PLANT NAMES: Nine Mile Point Unit No. 1

ENCLOSURES:
Proposed Change to Tech Specs for Nine Mile Point Unit No. 1

RE: Nine Mile Point Unit No. 1 Docket 50-220

The attached report describes a proposed change for Nine Mile Point Unit No. 1 in accordance with paragraph 50.59 of 10CFR Part 50. It is proposed that an Access Platform be added to the refueling bridge structure to expedite the refueling operation and also enhance safety.

FIGURE 1

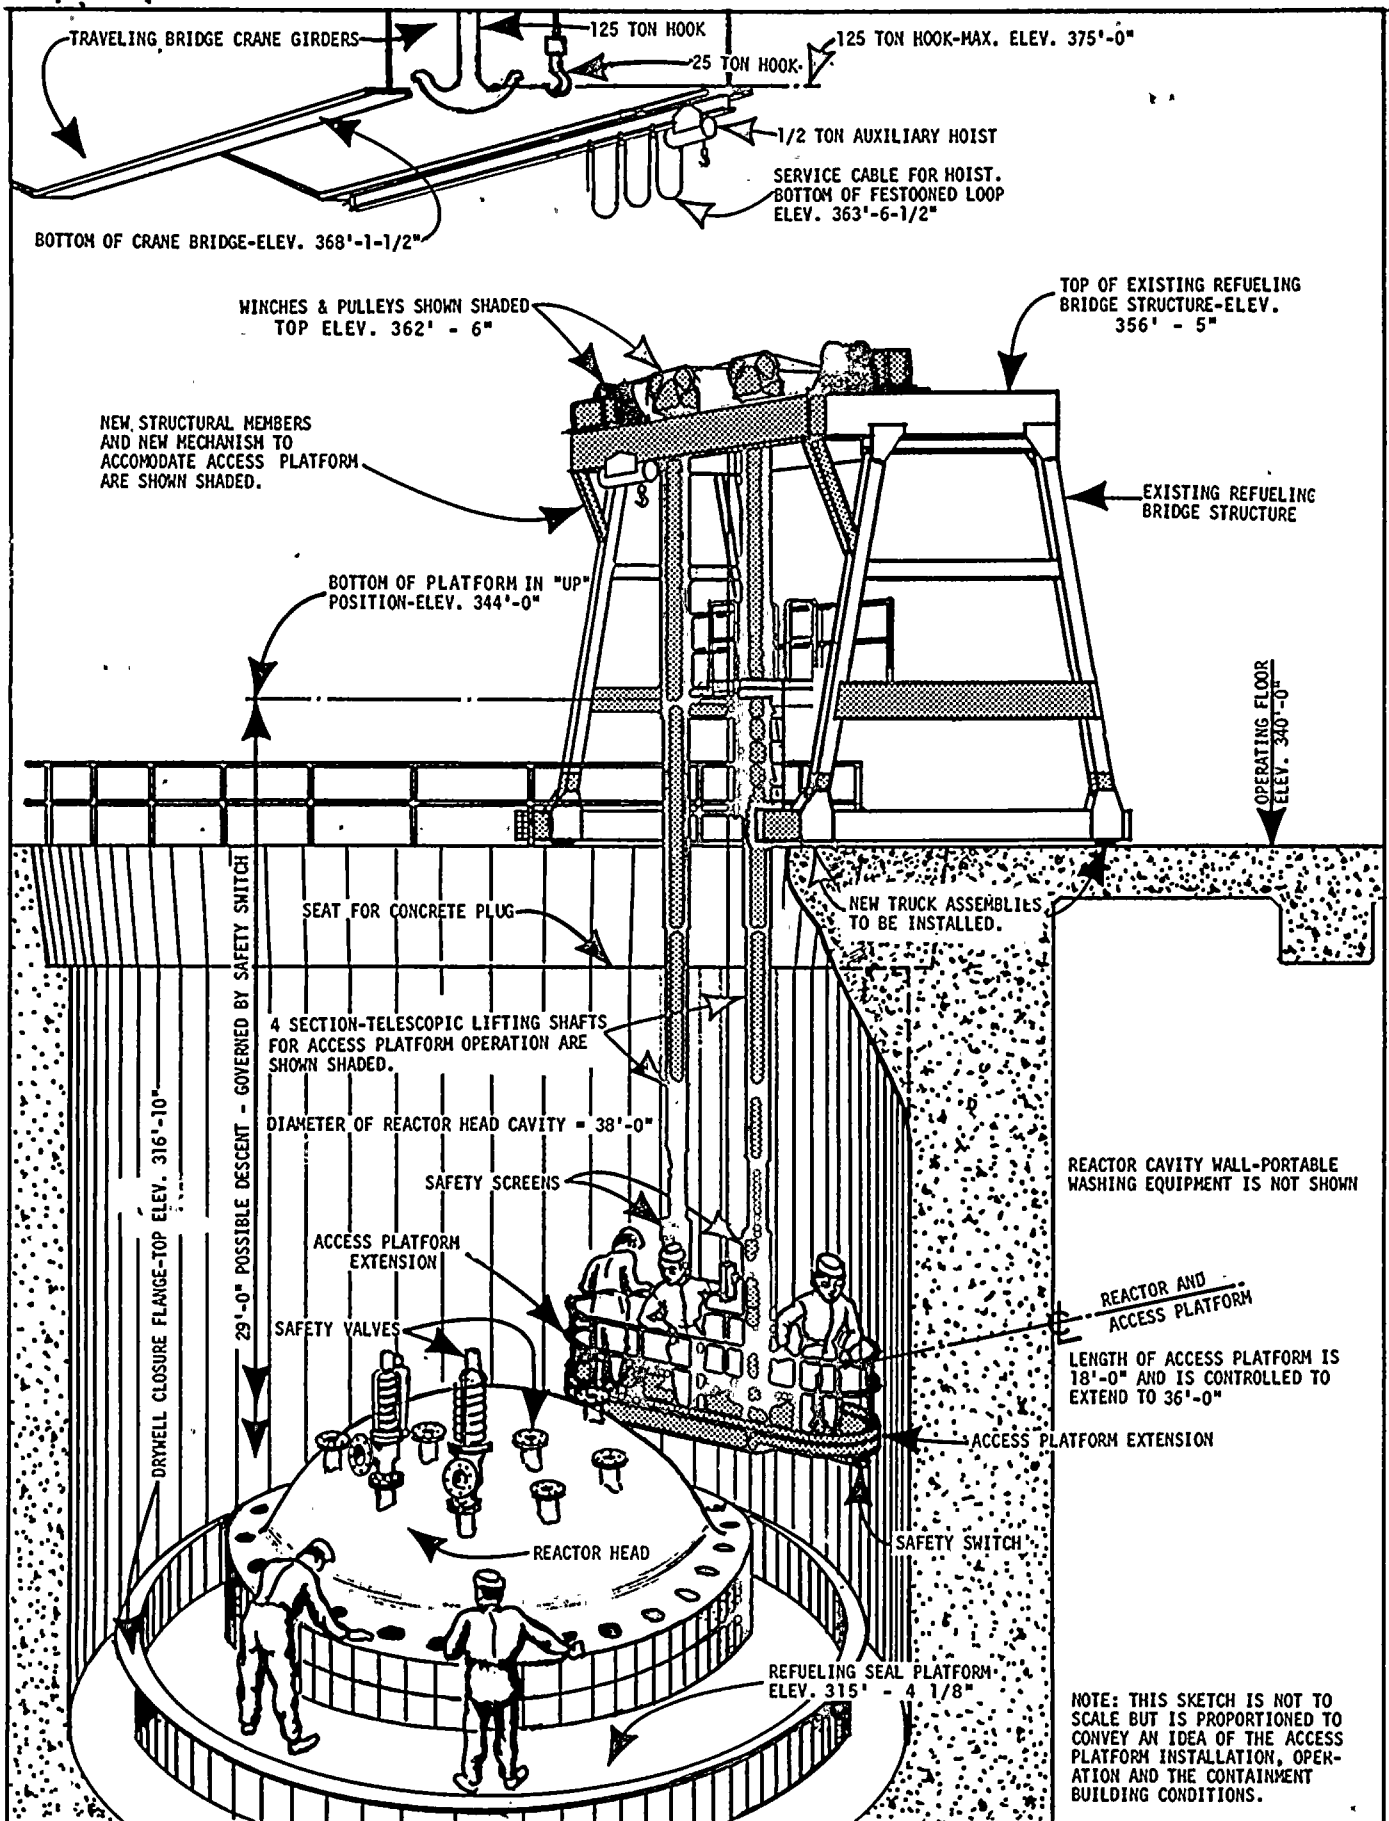
The Access Platform (as shown in Figure 1) for the Station consists of a main platform section with extendible sections at each end; two telescoping tube assemblies which attach the Access Platform to the refueling bridge structure; and two winch hoists, each of which can raise the Access Platform. With the extendible sections fully retracted, the overall length of the Access Platform is 18 feet (excluding any wall cleaning equipment). With the platforms fully extended the overall length of the Access Platform is 36 feet. This length permits access of the walls of the reactor cavity at the greatest width. The design characteristics of the Access Platform are summarized in Table 1. Wall-washing assemblies are mounted on the extendible platforms and can be positioned and locked at any point on the curved section of the extendible platform railing. The high pressure spray nozzles are mounted on a vertical manifold assembly which will maintain the nozzles perpendicular to the wall and at the distance required for efficient cleaning.

Modifications to the refueling bridge structure will be made to obtain smooth bridge operation. These modifications include:

1. Floating the wheels on one platform truck to eliminate wheel binding caused by leg spread.
2. Replacement of the existing walkway with a significantly stiffer structure, so as to afford better distribution of loads due to addition of Access Platform.
3. Replacement of existing bridge drive torque rods with stiffer torque tubes, eliminate wind up associated with current rods.

Some additional modifications to the refueling bridge structure are required to make it suitable for the addition of an Access Platform. These involve the addition of knee braces at each end of the upper structure, the addition of winch hoist mounting structure, the addition of a horizontal brace on each end frame, and the addition of decking above the monorail beam bracing to provide access to the platform components.
